Seabrook Station
NRC Generic Letter 96-06
Response to Request For Additional Information (TAC No. M96864)

**NRC GENERIC LETTER 96-06
RESPONSE TO
REQUEST FOR ADDITIONAL INFORMATION (TAC NO. M96864)**

ENCLOSURE 1 TO NYN-98122

NORTH ATLANTIC ENERGY SERVICE CORPORATION
NRC GENERIC LETTER 96-06
RESPONSE TO REQUEST FOR ADDITIONAL INFORMATION (TAC NO. M96864)

Figure 2 PCCW (CC) Loop B

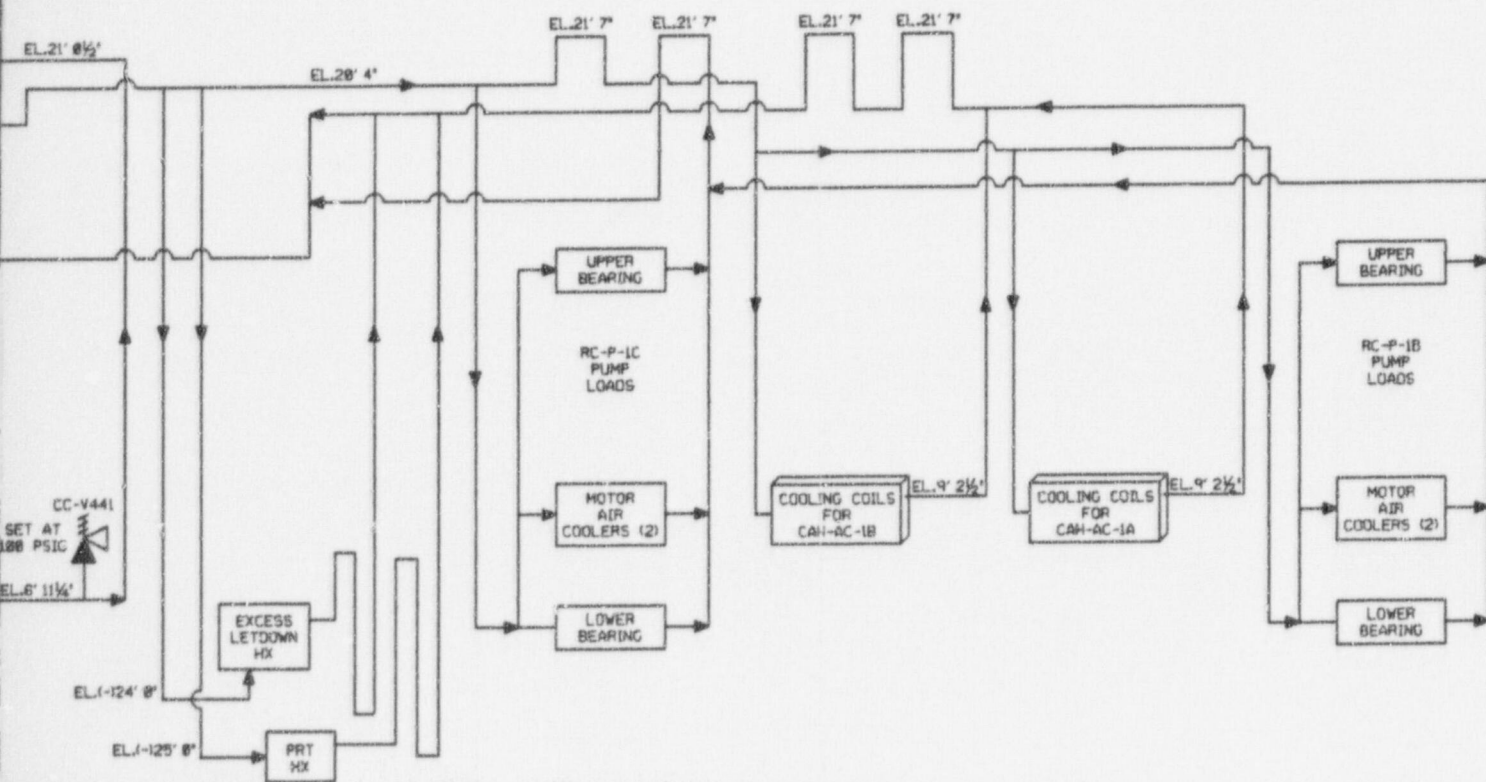
7. Provide a simplified diagram of the affected system, showing major components, active components, relative elevations, lengths of piping runs, and the location of any orifices and flow restrictions.

Response: Figures 1 and 2, attached, provide simplified diagrams for each of the two trains (loops A and B) of the PCCW system. Active components and relative elevations are shown. Although lengths of piping runs and orifices and flow restrictions are not shown, these components were used in the existing flow distribution calculations for the PCCW system. The resulting data from these calculations were used in North Atlantic's engineering evaluation. The pertinent P&IDs that show orifices and flow restrictions for the diagrammed portion of the system are provided in Figures 9.2-4 (sheets 1,3,4) and 9.2-6 (sheets 1,3,4,5) of the UFSAR (copies enclosed). The piping isometric drawings that were used to develop the figures also depict lengths of piping runs. These drawings are available for review at North Atlantic, if desired.
